PCN (Product Change Notice)

PCN Number: PCN_FeAEFA_20251221

Affected Series: WE-AEFA

DETAILS OF CHANGE:

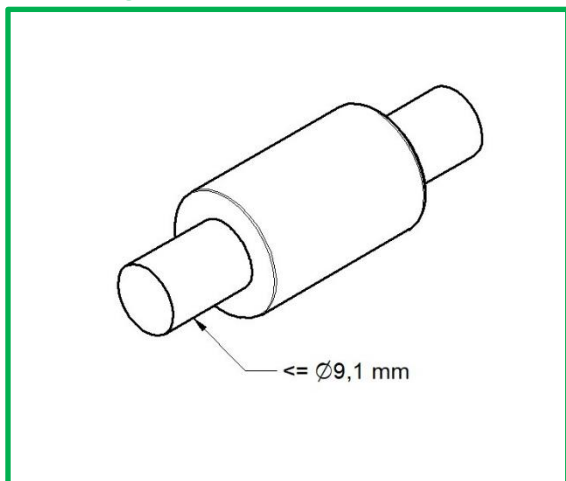
As a datasheet information amendment, Würth Elektronik eiSos will correct the dimension of the applicable cable diameter for the PN mentioned below.

before change

after change
